County of Fairfax, Virginia

TO: Plan Amendment ST10-IV-MV1 (Penn Daw CBC Special Study) Task Force

SUBJECT: Plan Amendment ST10-IV-MV1 Staff Impact Analysis

2011 Soils Map for PA ST10-IV-MV1

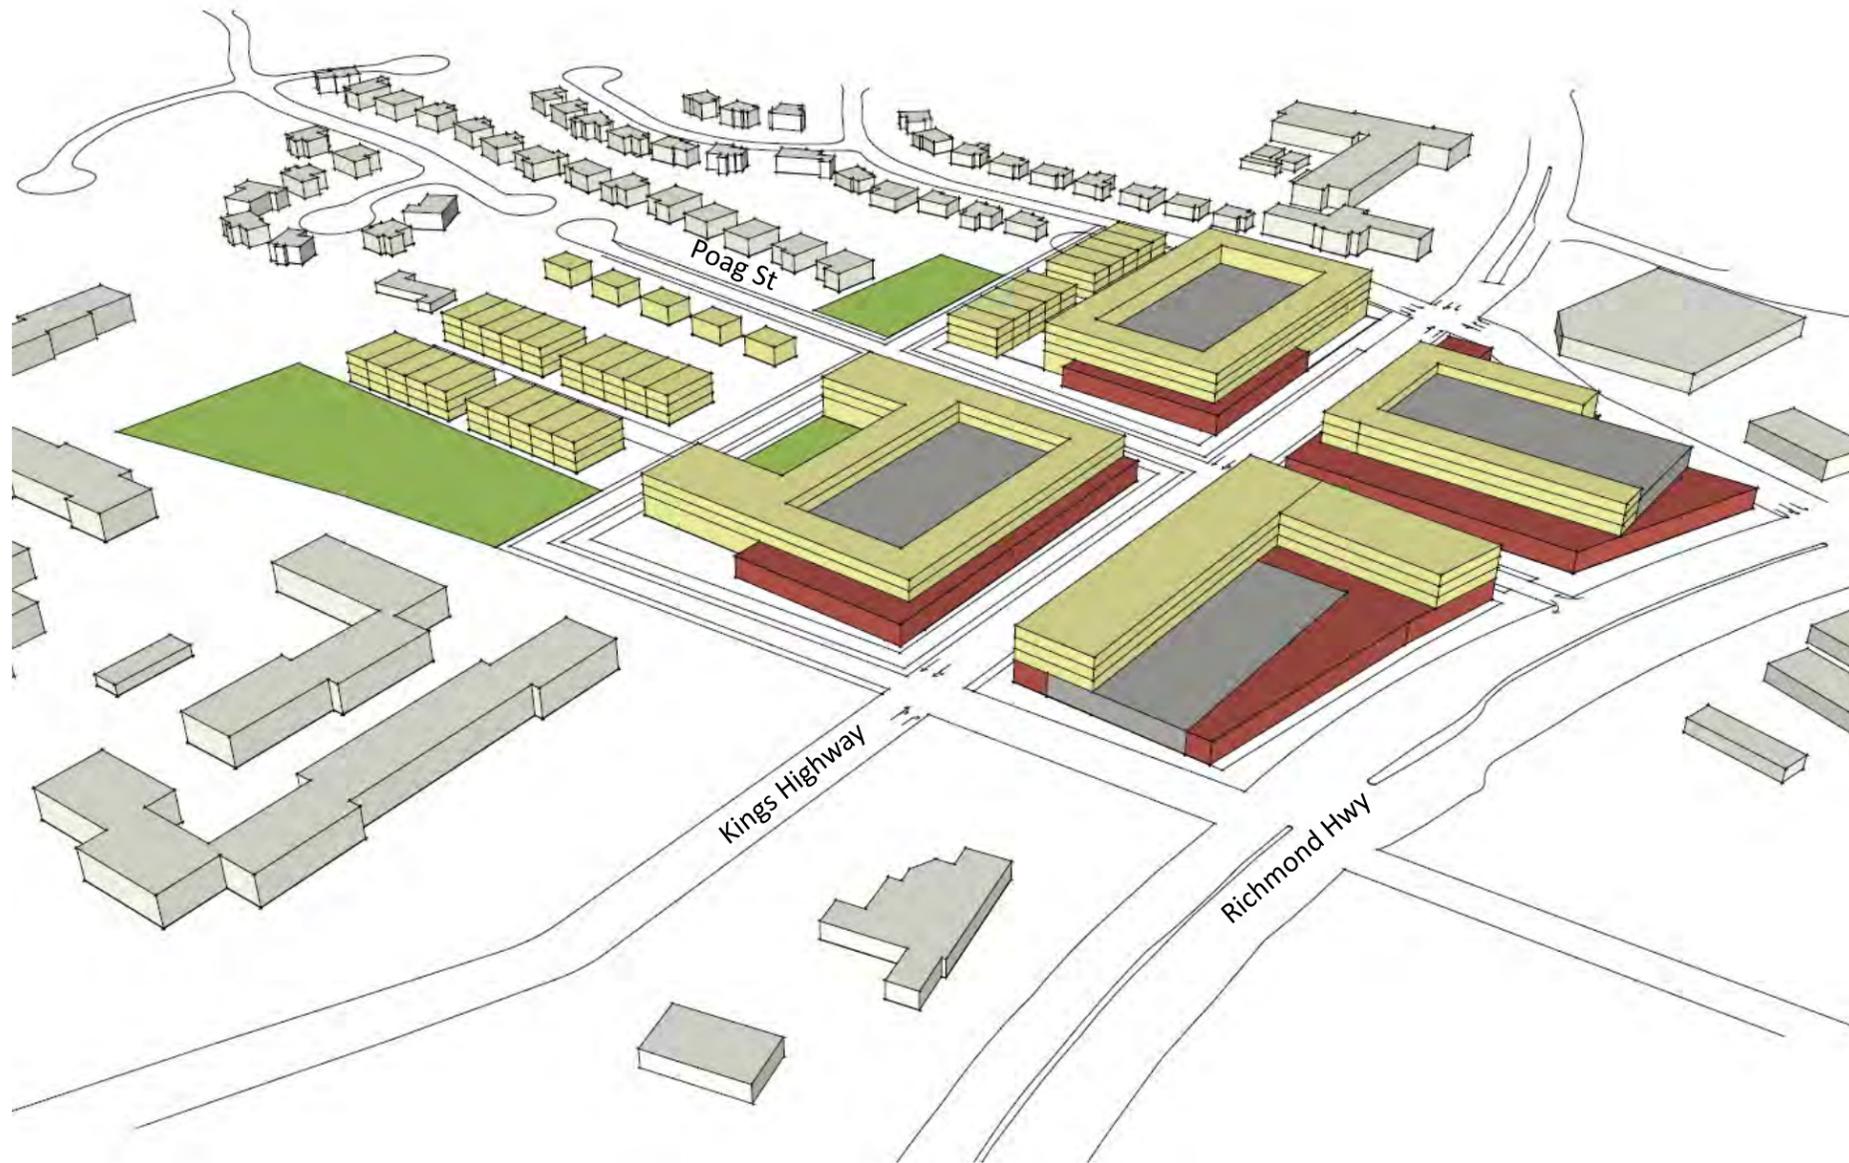
Problem Soils – The western portion of the site contains Marumsco Soils, classified as a problem soils. A geotechnical study may be required in order to determine the extent of these problem soils and any remediation measures, which might be required for development/redevelopment of the subject property. See page 7 for 2011 Soils Map.
